Re: NOV #N-90-18-2-1, Amax Coal Industries, Inc., Castle Gate Mine, ACT\007\004,  
Folder #5, Carbon County, Utah

Re: Sediment Pond Plans, Amax Coal Company, Castle Gate Mine

**RE:** Castle Gate Coal Company, NOV #N90-18-2-1 Abatement, ACT/007/004, Folder #2, Carbon County, Utah

# TYPICAL DECANT

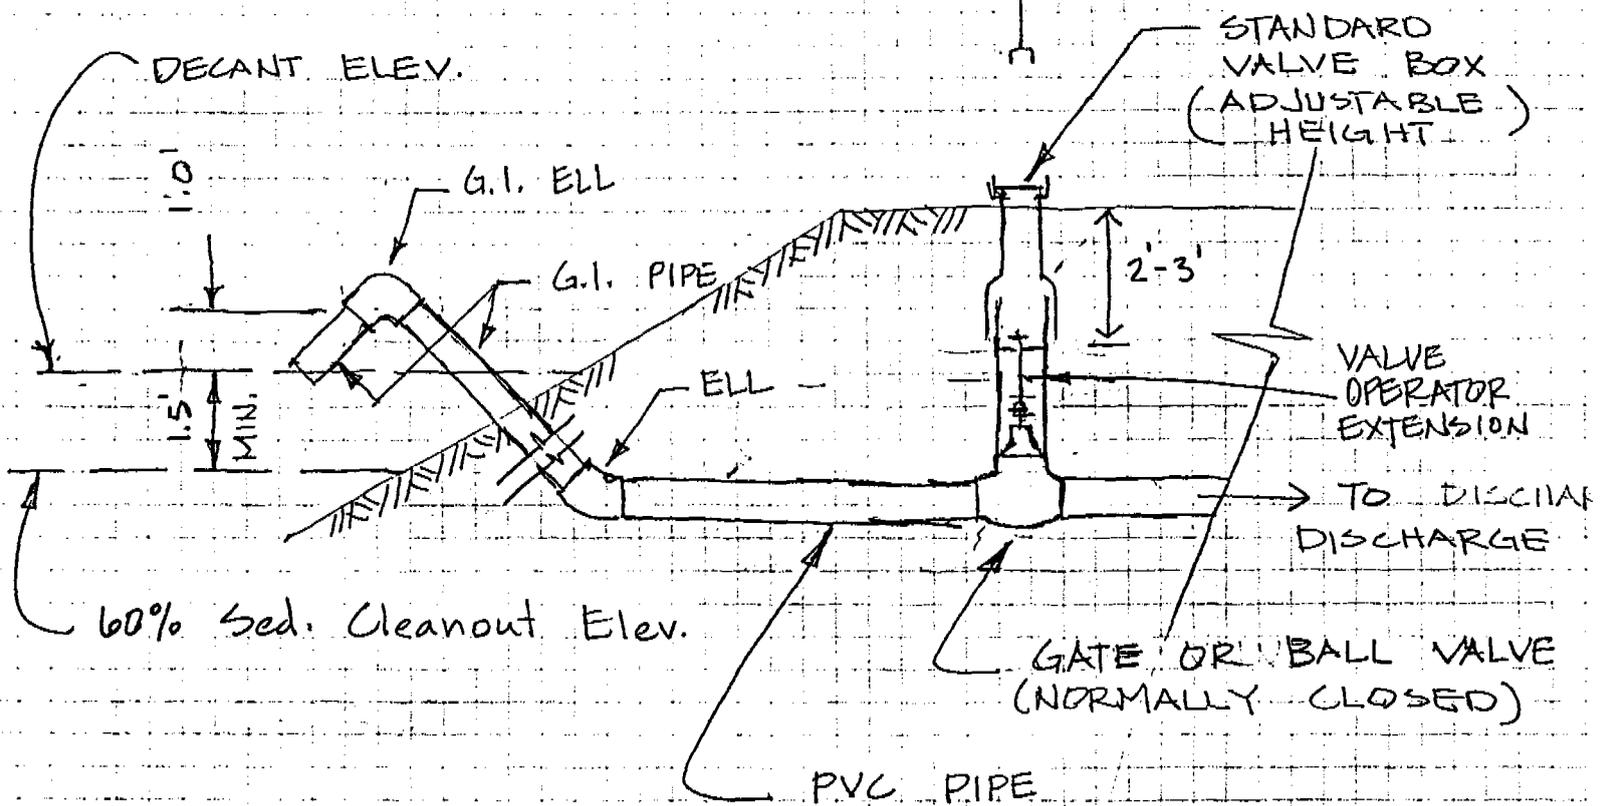
1. The decant design, typical for all ponds with decants, cannot be constructed as illustrated. The valve operator is perpendicular to the pipeline which would require a complicated housing and valve operator extension. I recommend a more simple design be considered.
2. I recommend at least 1.5 feet separation between decant and 60 percent cleanout elevation. This will provide improved sediment retention during pond drainage or storm events. In order to accommodate this, I suggest we allow the operators to count storage from the maximum sediment storage. This small amount of water evaporates and infiltrates quickly.

1. PROVIDE 2 VALVE KEYS (EXTENSIONS FOR OPERATING VALVE). KEEP ONE AT THE POND.
2. ALLOW OPERATOR TO COUNT STORAGE FROM 100% SED. ELEV. THIS WILL PROBABLY BE .5' BELOW DECANT.
3. USE GALVANIZED IRON (G.I.) PIPE FOR DURABILITY WHERE EXPOSED.
4. TURN DOWN PIPE IS MUCH SIMPLER TO CONSTRUCT (GREASE & FLOATABLE SEPERATOR)
5. GLOBE VALVES ARE MORE EASILY OPERATED ( $\frac{1}{4}$  TURN REQ'D TO OPEN OR CLOSE).  
TO OPEN OR
6. PROVIDES BETTER SED. RE REMOVAL.
7. VALVE OPERATOR EXTENSIONS W/ CENTERING DEVICE REQ'D. FOR PIPE BURIAL GREATER THAN 4'.
8. VALVE COULD BE INSTALLED NEAR DISCHARGE TO DECREASE BURIAL DEPTH.

**The operator must make the decant design changes required by the State Health as indicated in attachment letter dated August 23, 1991.**
